Service Update

16195 Brake Lamps Remain Activated

Reference Number: N162068110

Revision: 01

4690695

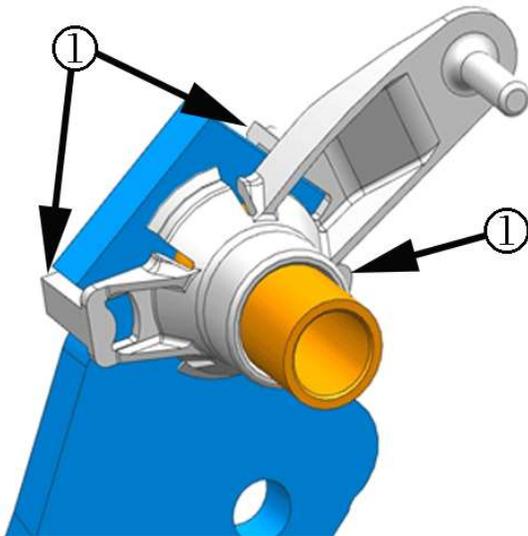
Revision Description: This bulletin has been revised to include a new inspection procedure. In addition, an add time for this new inspection is provided if a second inspection is required. Only use the add time when a second inspection is required. Perform the new inspection on vehicles that failed the first inspection and have not been repaired due to part availability. If the vehicle passes the new inspection, part replacement is not required. Close the field action bulletin using the add time provision in the Warranty Information section of the bulletin. Please discard all copies of 16195.

Brake and accelerator pedal assembly shown out of vehicle for illustration purposes. Paint pen scribe mark (3) shows relationship between the base of the BPPS switch bracket and bracket shaft. Two-sided arrow (2) indicates rotation path of the BPPS switch bracket.

- Using your fingers, rotate the BPPS switch activation bracket back and forth (2) to determine if there is any movement at the base of the bracket and bracket shaft (3).

- If there is 1 mm (3/64 in) or less of movement in any direction or less than 2 mm (5/64 in) of movement total in both directions and the brake lights do NOT remain on after attempting to rotate the BPPS switch activation bracket, no further action is required.
- If there is more than 1 mm (3/64 in) of movement in any direction or over 2 mm (5/64 in) movement total in both directions and the brake lights remain on after attempting to rotate the BPPS switch activation bracket, replace the brake and accelerator pedal assembly. Refer to *Brake and Accelerator Pedal Assembly Replacement* in SI.
